**R10RW**

# Incorrect Power Cable Lug Orientation

Models Affected: 2004 through 2009 Vision

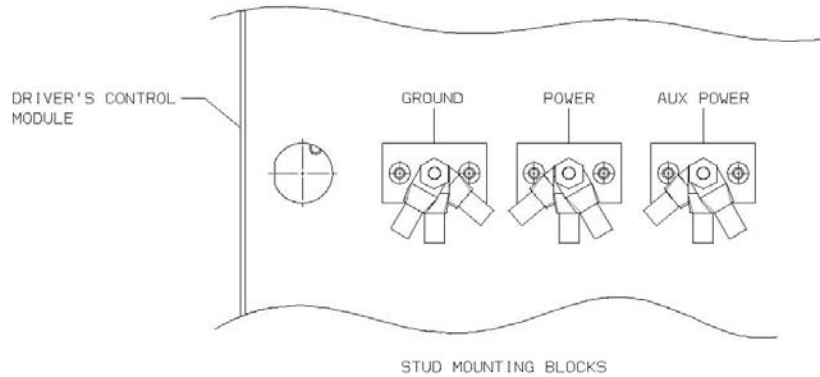
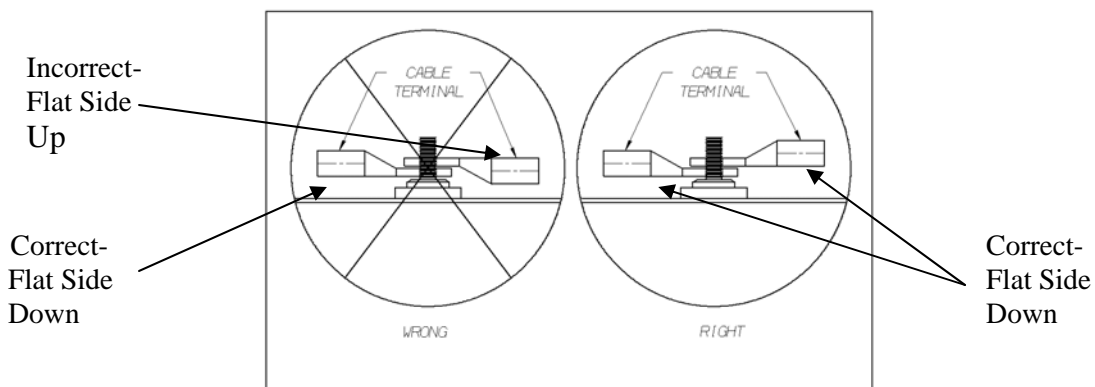
1. Park the vehicle on a level surface, apply parking brake, turn engine off, remove ignition key and chock wheels.
2. Disconnect batteries. *Always remove negative cables first.*
3. Open engine hood and locate the Chassis Power Stud(s) on the driver's side of the **Driver's Control Module (DCM)**. Depending on the type of engine installed and options on the vehicle (air conditioning and/or lift), there could be one or two power studs next to the Ground Stud. See the following diagrams.

4. Inspect the electrical cable connections at the Power Stud and Aux Power Stud, if installed. See the diagram below to determine if the cables were installed correctly. ALL terminal lugs on each power stud should be oriented such that the barrel of the lug is further away from the mounting surface of the isolated stud. The flat side of terminal end (lug) must be down.

5. If the cables were installed incorrectly, remove the nut securing the cables. Then remove the cables and reinstall correctly per the diagram above. Make sure the terminal lugs are fanned out on the stud as opposed to directly on top of each other. Vice-grip pliers are recommended when turning incorrectly installed cable terminal lug to the correct orientation of flat side down.

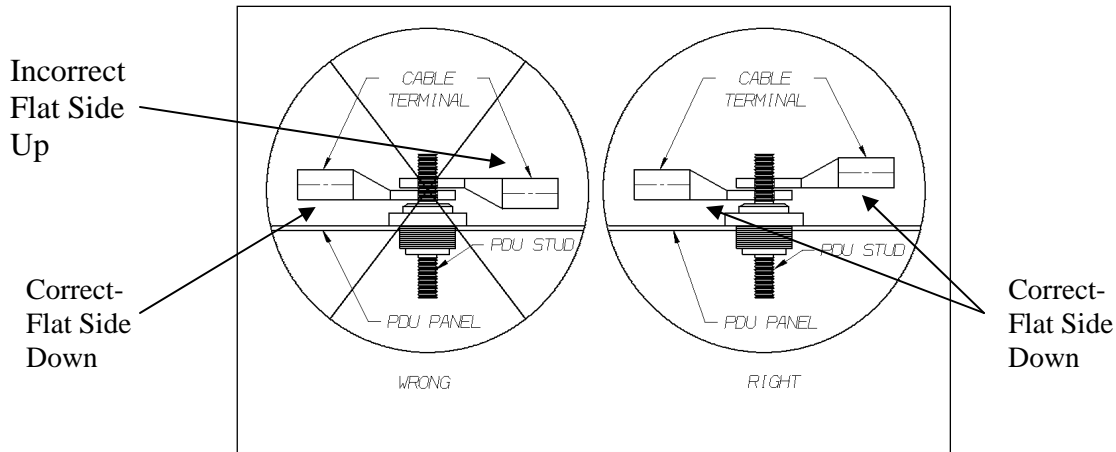
9. Next, locate and inspect the two Power Studs below the 4 Deutsch connectors.

10. Remove the two red protective covers and inspect the electrical cable connections at the Power Studs.

ALL terminal lugs on each power stud should be oriented such that the barrel of the lug is further away from the mounting surface of the isolated stud. The flat side must be down.

11. Remove the nut securing the cables. Then remove the incorrectly installed cables and reinstall correctly with flat side down. Make sure the terminal lugs are fanned out on the stud as oppose to directly on top of each other.
12. If needed, use vise grips to rotate cable so lug fits with flat side down. See photo on page 2.
13. Secure the cables with the nut and torque to 12 to 15 ft-lbs.
14. Apply corrosion resistant coating (glyptal) as required to prevent corrosion.
15. Reinstall the red protective covers.
16. While having access to this area, inspect ALL power cables for any evidence of contact with the rear of the engine, chaffing, or other damage. **Ensure clearance between power cables and any part of the engine is more than 1/2 inch.**
